CORNERSTONE (MINOR PLAT)

SUMMARY

<p>Applicant Daniel Ray Holt, PSM American Survey and Mapping</p> <p>Owner Laura P. Sims, President Cornerstone Commercial Condominium Association, Inc.</p> <p>Project Planner Jacques Coulon</p> <p><i>Updated: May 4, 2016</i></p>	<p>Property Location: 120 and 150 N. Orange Ave. (south of W. Jefferson St., north of W. Washington St., east of N. Gertrude Ave., west of N Orange Ave.) (Parcel #'s; 26-22-29-1607-00-001, 26-22-29-1607-01-000; 0.18 acres, District 5).</p> <p>Applicant's Request: Replat of two adjoining lots to make minor shifts to lot lines. New lots will be: Lot 1 150 ft. (w) x 309 ft. (d); Lot 2 65 ft. (w) x 150 ft. (d).</p>	<p>Staff Recommendation: Approval of the replat, subject to conditions in this staff report.</p>
---	---	---

PROPOSED PLAT

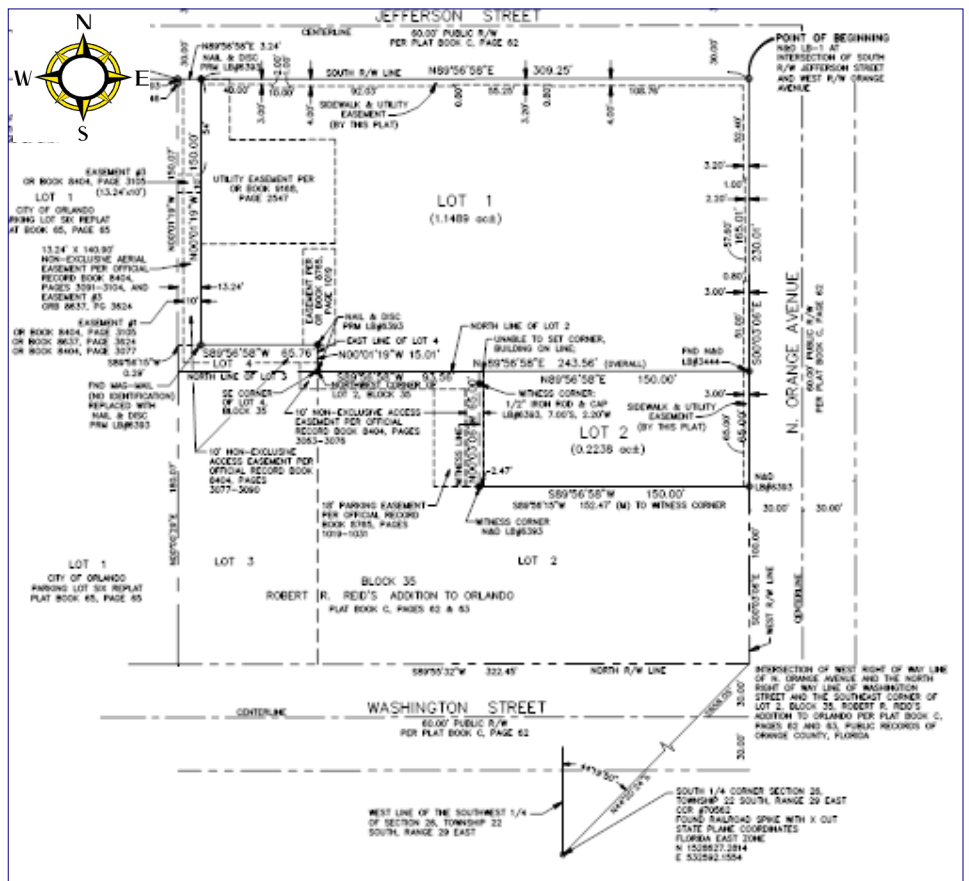
1. Please change street names to read "W Jefferson St" and "N Orange Ave" to match city records.
